# Product Change Notification

Date Issued :	December 05, 2022	PCN Number :	513080
Reason for Change :	Equipment Transfer, Production Transfer or Rearrangement		
Description of Change :	This notification is to inform you about transfer the subassembly process: LED bending and assembly from Molex Chengdu factory to Molex Chengdu's subcontractor		
Reason for Short Notice :	Special Request		
Assessment of Change :	First Article Inspection		
Planned Implementation Date :	March 10, 2023		
Sample Availability Date:	February 10, 2023		
Internal Molex Qualification Date :	February 10, 2023		
Last date to request Samples by Customer :	February 01, 2023		
Traceability Code Markings / Date :	Date code

Before Picture

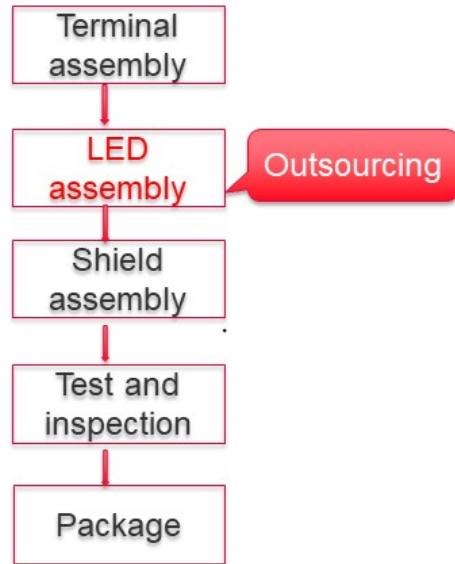
- In order to optimize the process to support the automation line assembly, transfer the subassembly process: LED bending and assembly from Molex ChengDu factory to Molex ChengDu's subcontractor, the LED assembly process is part of connector assembly. The final connector assembly process will be still in Molex ChengDu plant. The tools/fixtures for LED assembly will be transferred. No change on the process and material.
- No impact to customer functional, fit and forming.
- Part Number Impact: "see attached impacted parts list"
